Service Bulletin No. 374

MODEL E / J Series Coaches	TYPE Field Change Program	SECTION/GROUP 6 – Cooling	DATE Jan. 13, 2012
SUBJECT LINNIG FAN CLUTCH COOLING RING			
CONDITIONS

TOPIC OF DISCUSSION: Checking for defective cooling ring on LINNIG fan clutch: LA1.3.011Y, LA1.3.013Y & V1821Y; MCI p/n: 06-06-1220 & 06-06-1582

Figure 2. Reference photo of missing portion of cooling ring fins.

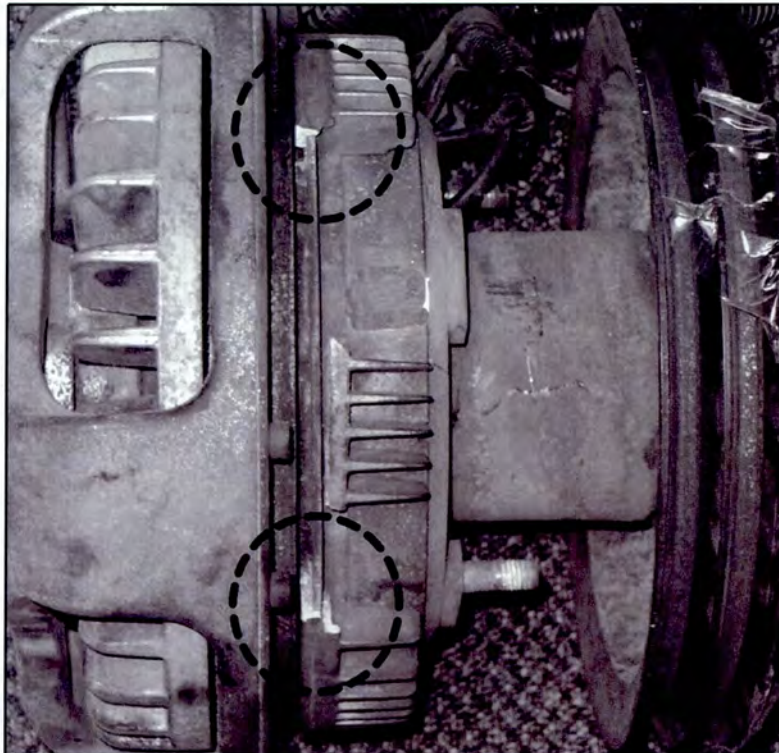
Customers may experience stress cracks and/or missing portions of the fan clutch cooling ring fins.

The cause is due to vendor (Linnig) manufacturing process.

6. Using a clean cloth, clean the fan clutch and cooling ring.
7. Visually inspect the entire fan clutch cooling ring (cooling ring will spin freely with the belt removed) for evidence of stress cracks and/or missing portions of the fins (refer to Figure 2 below, in addition to the attached Linnig Service Bulletin / Checking for Defective Cooling Ring on Linnig Fan Clutch).

Upon completion of visual inspection, if the fan clutch cooling ring displays evidence of stress cracks and/or missing portions of the fins, contact the MCI Fleet Support Technical Center at 1-800-241-2947 for fan clutch cooling ring replacement information. Re-install the belt and close the engine compartment door. Return the wheel wrench and handle to the drag link compartment. No further action required. Procedure complete.

Figure 1: Exhibits the fan clutch that is affected

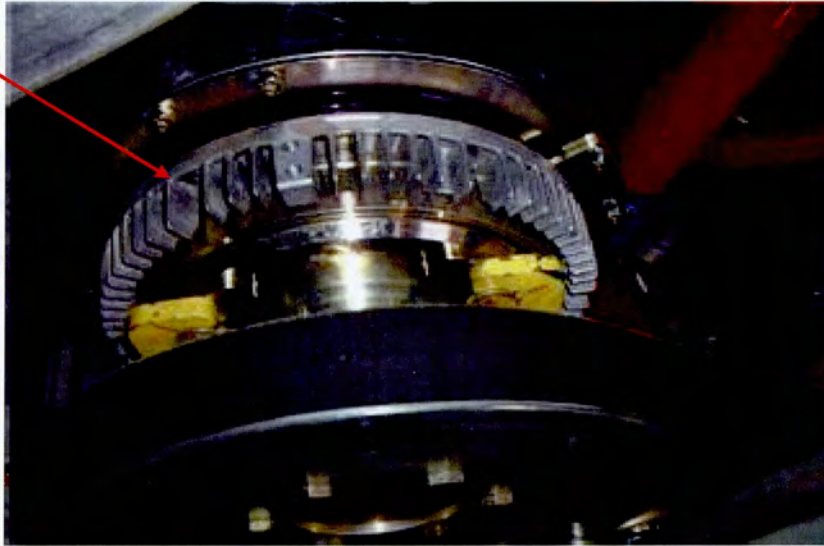
- Shut off engine & power supply to the clutch prior to inspection
- Conduct a clutch inspection prior to any scheduled or unscheduled maintenance to the coach with the engine and power shut off
- Locate the cooling ring that is affected on the fan clutch (See figure 1)
- Inspect the cooling ring for defects such as stress cracks or missing portions (See figure 2 & 3)
- A routine clutch inspection should be conducted during every oil change and normal PM intervals
- If any defects are present, replace the fan clutch (06-06-1220) immediately to avoid further damage(s) or injury
